ADDENDUM NO. 4

Reference: Student Activity Center Addition to the Stromberg Athletic Complex
Weber State University – Ogden, Utah
DFCM Project No. 12031810

Addendum 004

project:	WSU Stromberg Student Activity Center	**project no:**	12475
date:	2012-10-22	**no. pages:**	97
owner:	DFCM		
contractor:			
bid date:	2012-11-01	**bid time:**	12:00 pm

C3 CSC 110 SLIDING WINDOW COUNTER
SCALE: 1 1/2" = 1'-0"

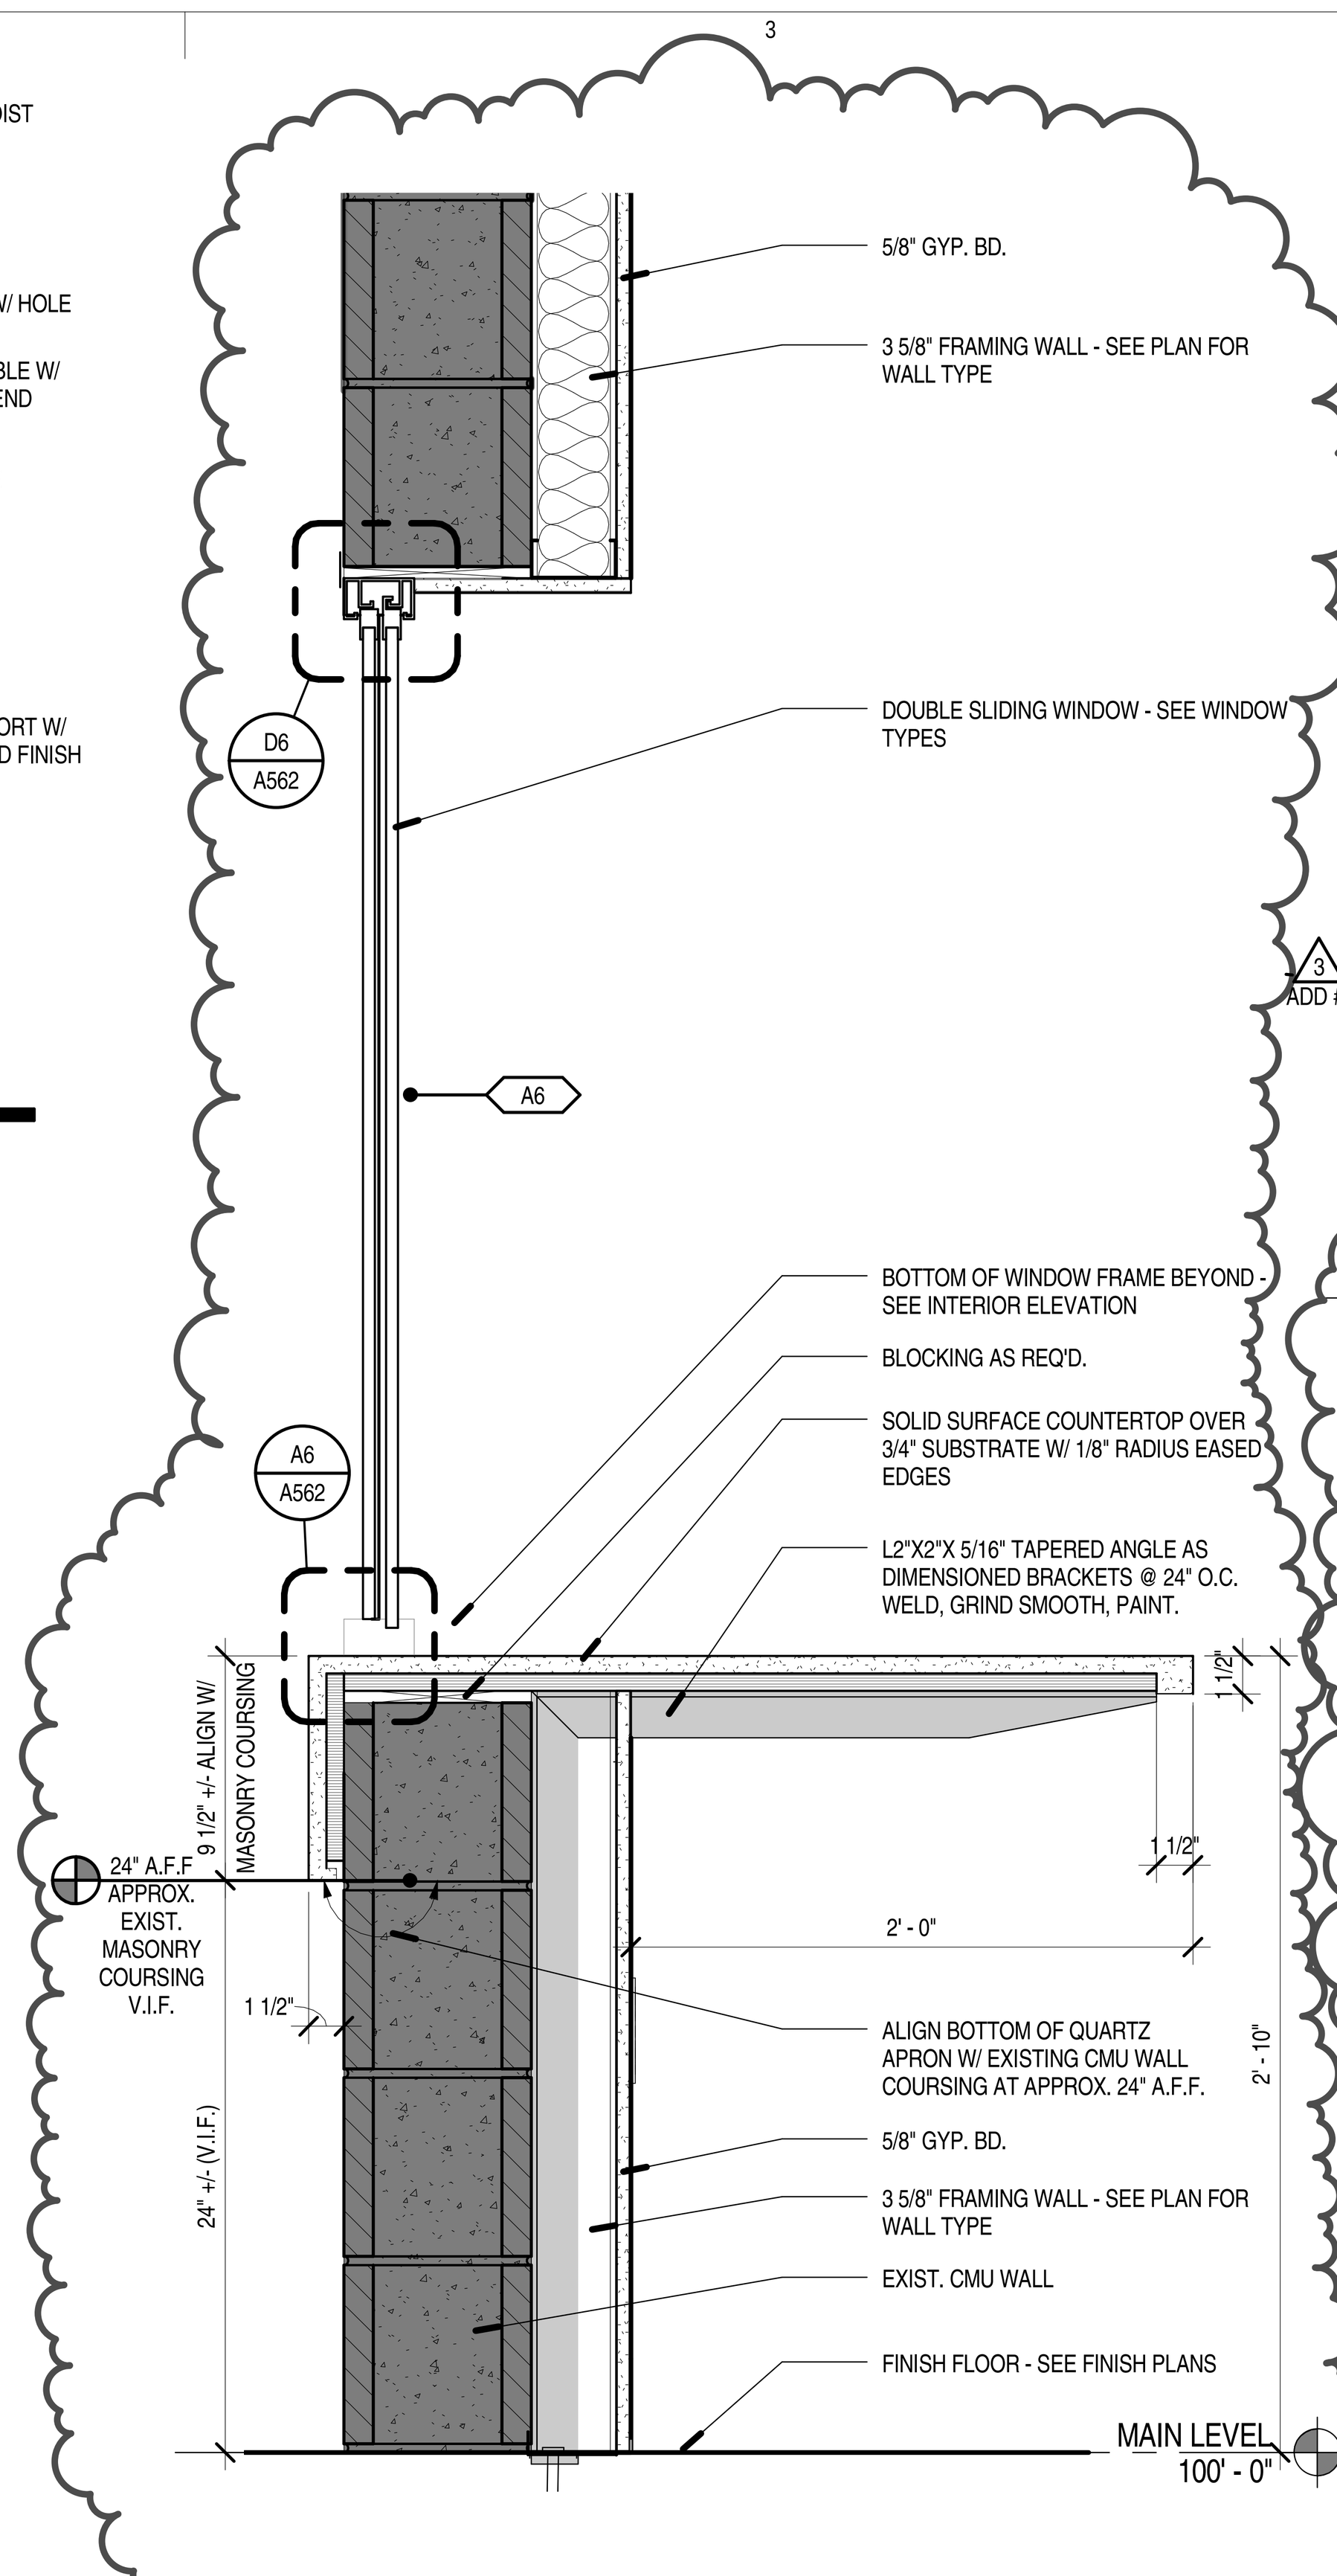
4.6	A572	See attached for added detail C3/A572 - CSC 110 Sliding Window Counter and revised Ceiling Anchor Detail C4/A572.
4.2	A580	See attached for added detail D4/A580 - Handrail at CMU Wall.

MEZZANINE CEILING FRAMING PLAN A/S132.1
SCALE : 1/8" = 1'-0"

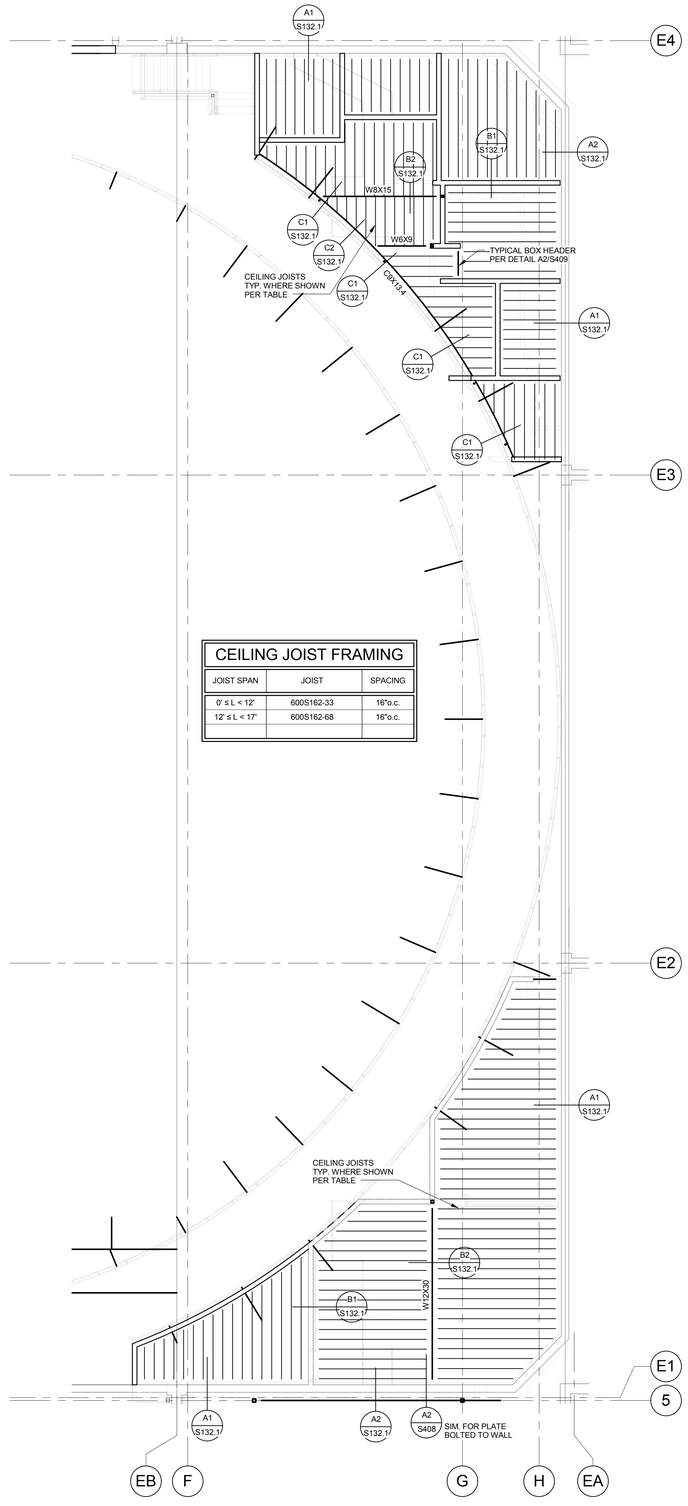
Sheet S132.1
-This is a new sheet with the mezzanine ceiling framing plans and details.
